SUBJECT: ISSUANCE OF AMENDMENT NO. 19 TO FACILITY OPERATING LICENSE NO. NPF-51
FOR THE PALO VERDE NUCLEAR GENERATING STATION, UNIT NO. 2
(TAC NO. 66784)

AMENDMENT TO FACILITY OPERATING LICENSE

Amendment No. 19
License No. NPF-51

ENCLOSURE TO LICENSE AMENDMENT

FIGURE 3.1- 1A

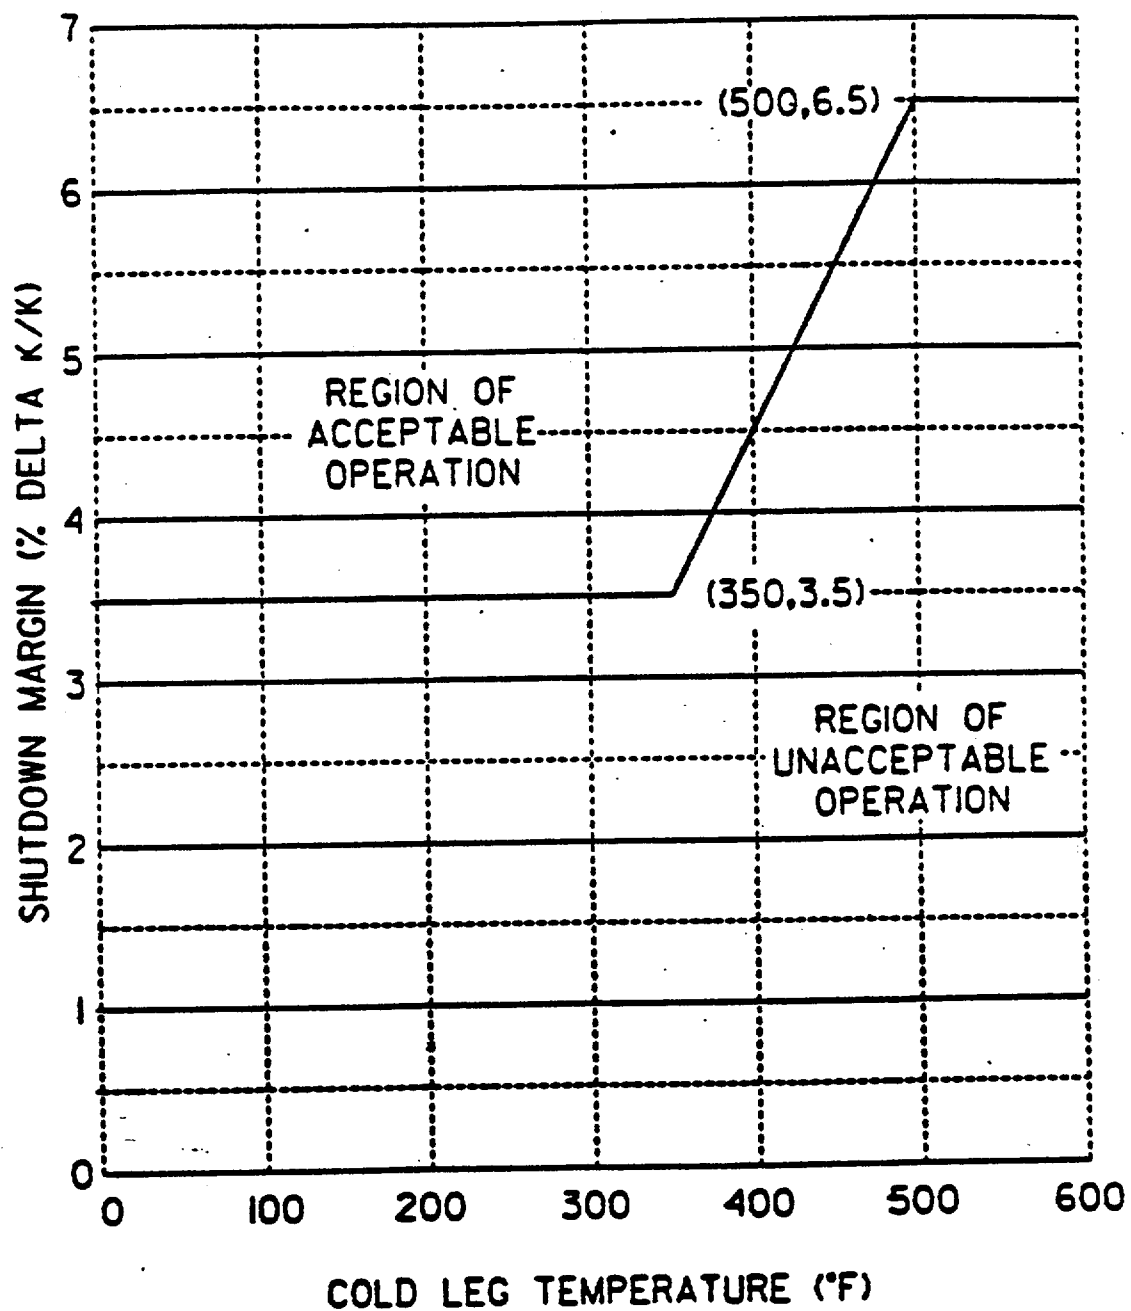
- (1) The shutdown margin versus cold leg temperature curve given in Figure 3.1-1A of Technical Specification 3.1.1.2 has been changed to increase the required shutdown margin value from 6.0% delta k/k to 6.5% delta k/k at cold leg temperatures above 500°F.

The increased shutdown margin is required to ensure that the steam line break event at hot zero power, which is the most limiting accident with regard to shutdown margin requirements for Cycle 2, is bounded by the reference cycle (Cycle 1) analysis. Sufficient CEA trip reactivity worth is available to meet the shutdown margin requirements even with the most reactive CEA assumed stuck in the fully withdrawn position. The staff, therefore, finds this change acceptable.

FIGURE 3.1-3
CEA INSERTION LIMITS VS THERMAL POWER
(COLSS IN SERVICE)

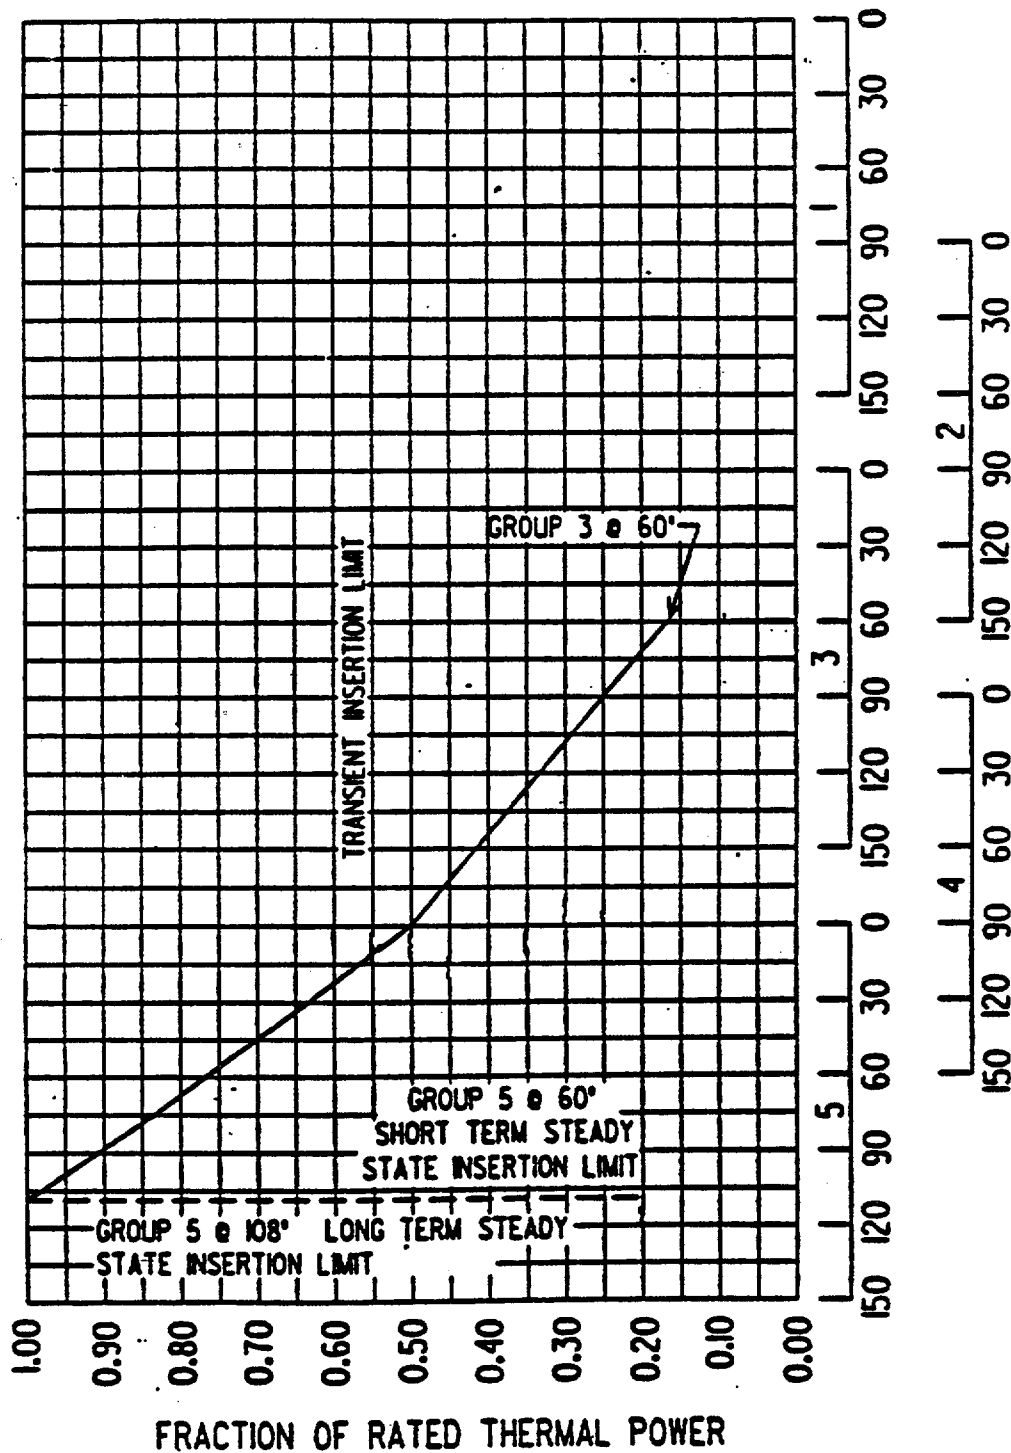
- (7) The CEA insertion limits given in Technical Specification 3.1.3.6 have been revised to account for changes in the reactivity worth of the CEAs due to changes in the Cycle 2 core.

Since the reactivity worth of the CEAs has changed, the consequences of the dropped and ejected CEA events are affected. The revised CEA insertion limits chosen, which were calculated by approved methods, ensure that there is sufficient margin to mitigate such events during Cycle 2. The CEA insertion limit revision is, therefore, acceptable.

FIGURE 3.1-5
PART LENGTH CEA INSERTION LIMIT VS THERMAL POWER

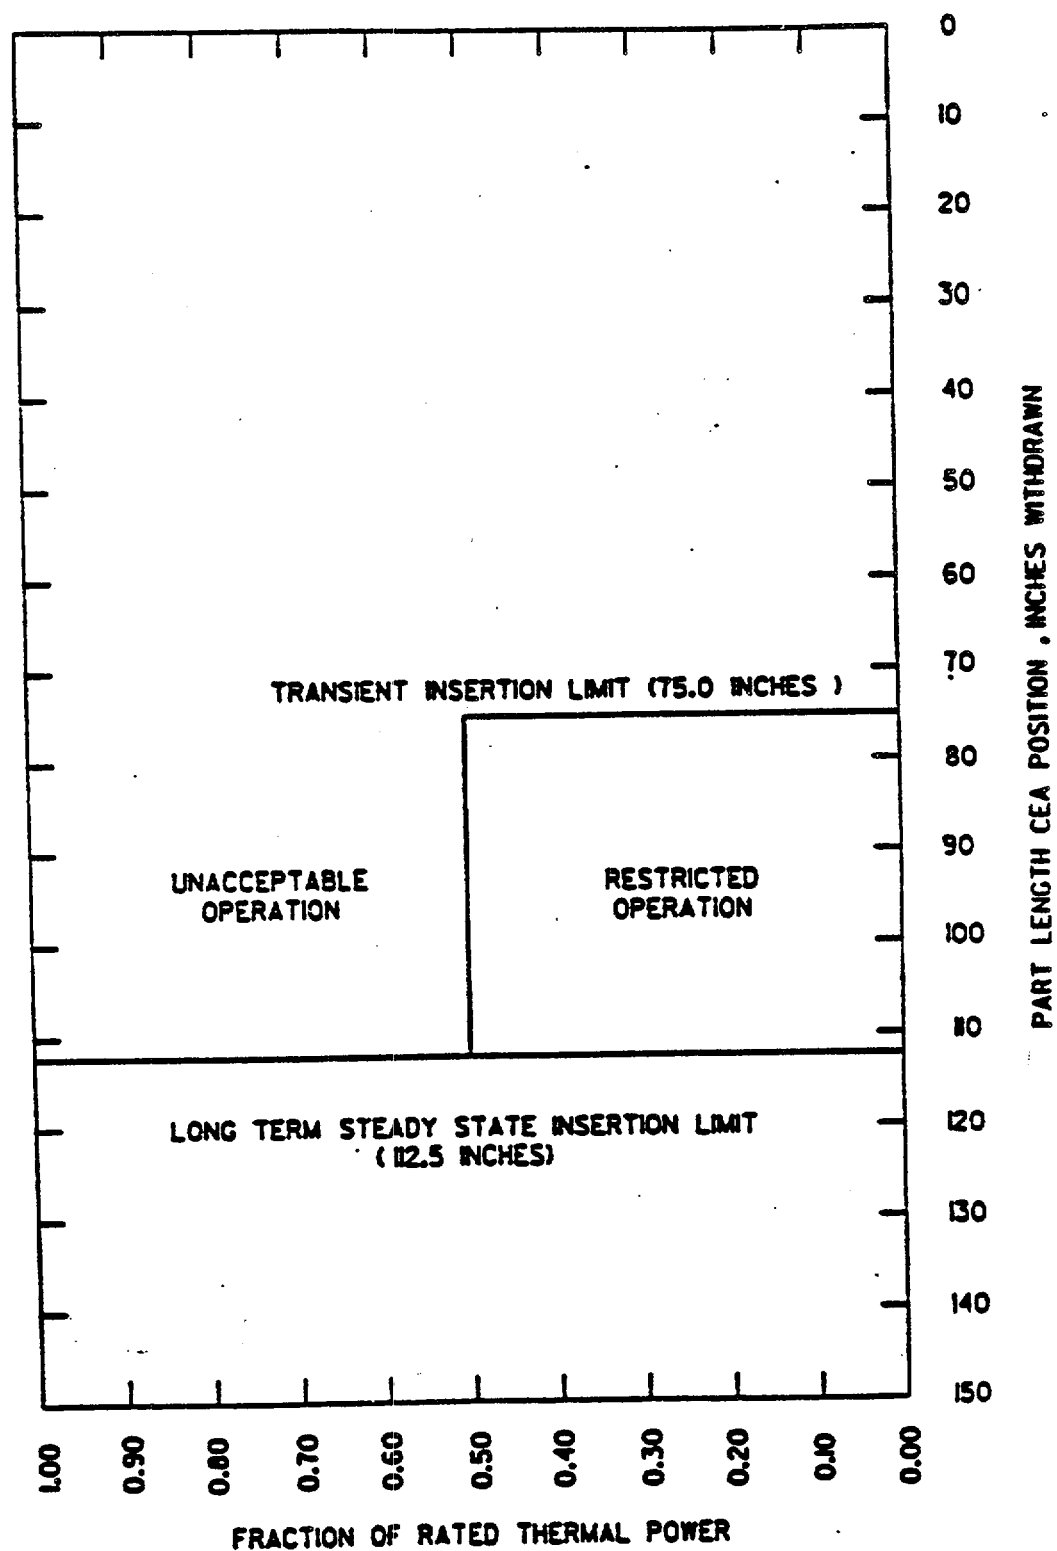
- (4) Reference to the part length CEA insertion limits have been removed from Technical Specification 3.1.3.1 and a new Specification 3.1.3.7 has been added to specify the length of time for insertion and the insertion limit of the part length CEAs specifically.

The new Specification adds a more explicit LCO to clarify the allowable duration for a part length CEA to remain within the defined ranges of axial position and reduces the potential adverse consequences of a part length CEA drop or misalignment from an allowable position. The changes are, therefore, acceptable.

FIGURE 3.2-2

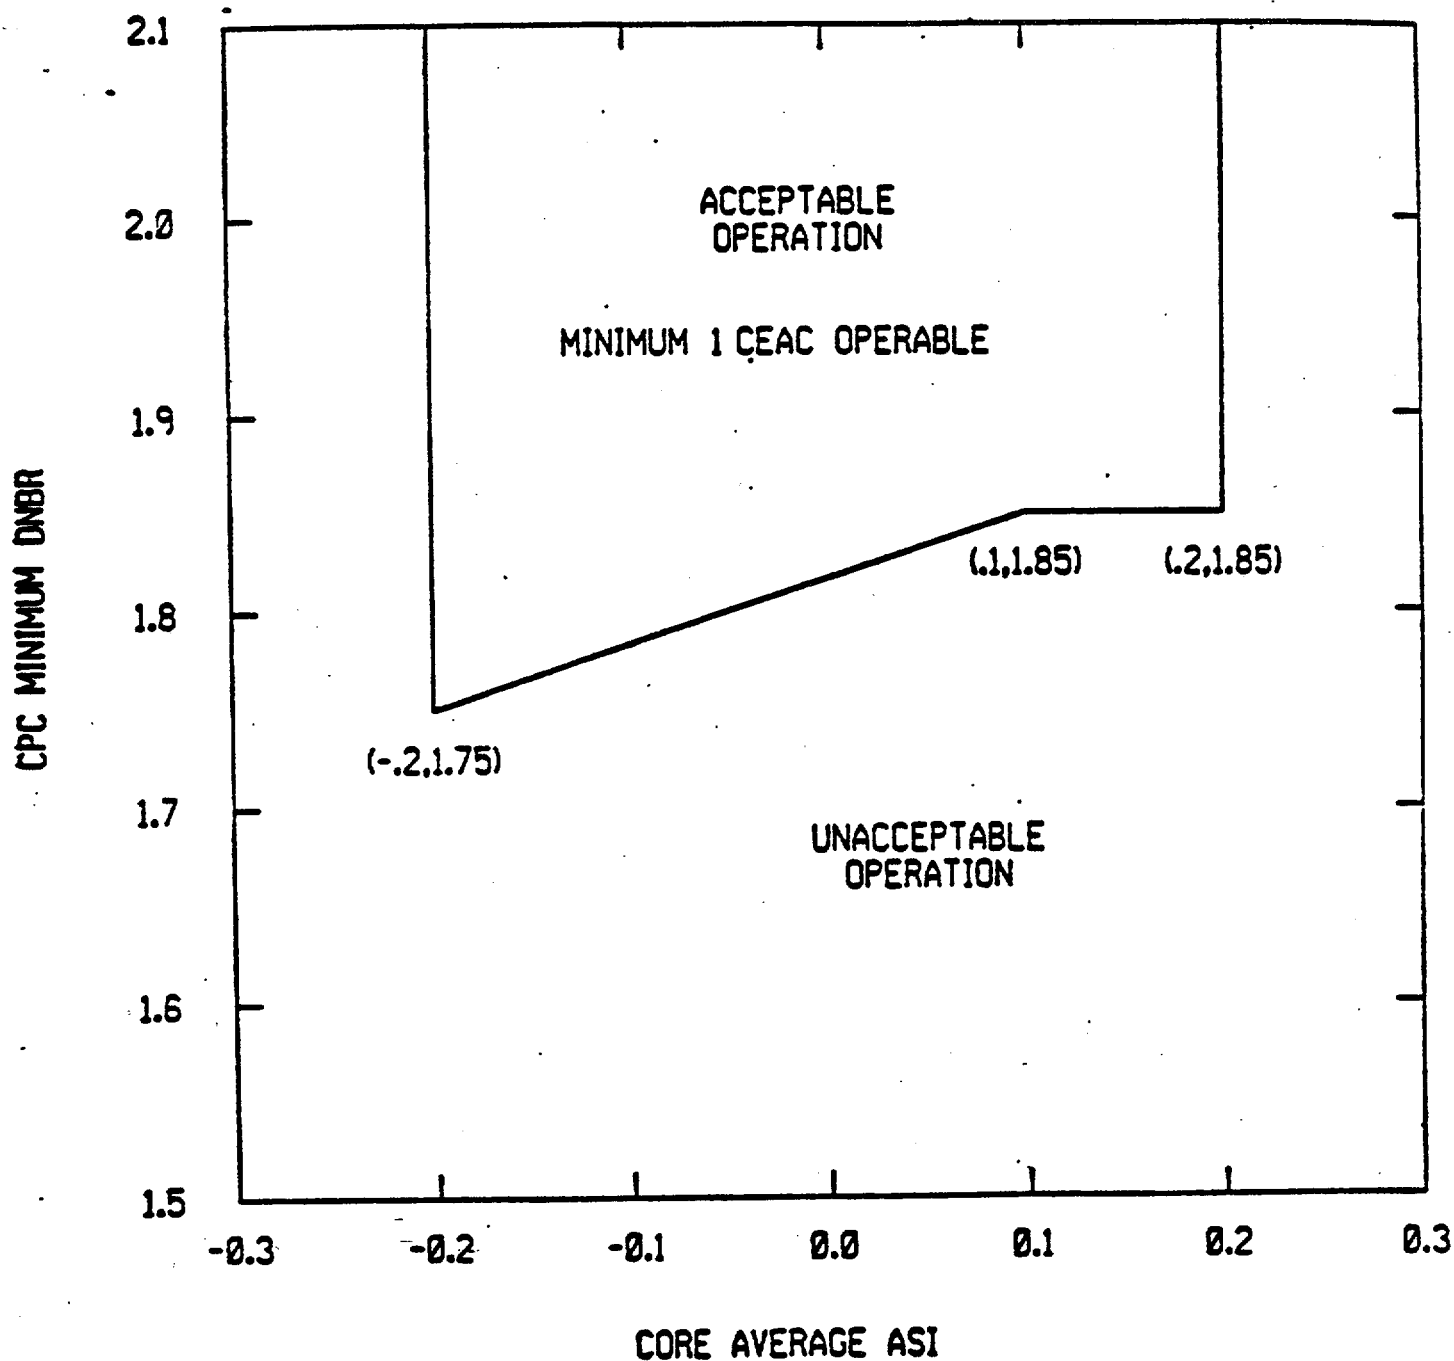
- (11) Technical Specification 3.2.4 has been replaced with a new format which (a) addresses the specific conditions for monitoring DNBR with or without COLSS and/or the CEACs, (b) delineates what Actions should be taken, (c) removes reference to the DNBR penalty factor table used in Technical Specification 4.2.4.4, and (d) replaces Figures 3.2-1 and 3.2-2 with new Figures 3.2-1, 3.2-2, and 3.2-2A. In addition, as a result of being incorporated into the new Technical Specification 3.2.4, references to operation with both CEACs inoperable and the graph of DNBR margin operating limit (Figure 3.3-1) have been removed from Technical Specification 3.3.1. Bases Sections 3/4.1.3 and 3/4.2.4 have also been modified due to Cycle 2 differences and the above mentioned changes.
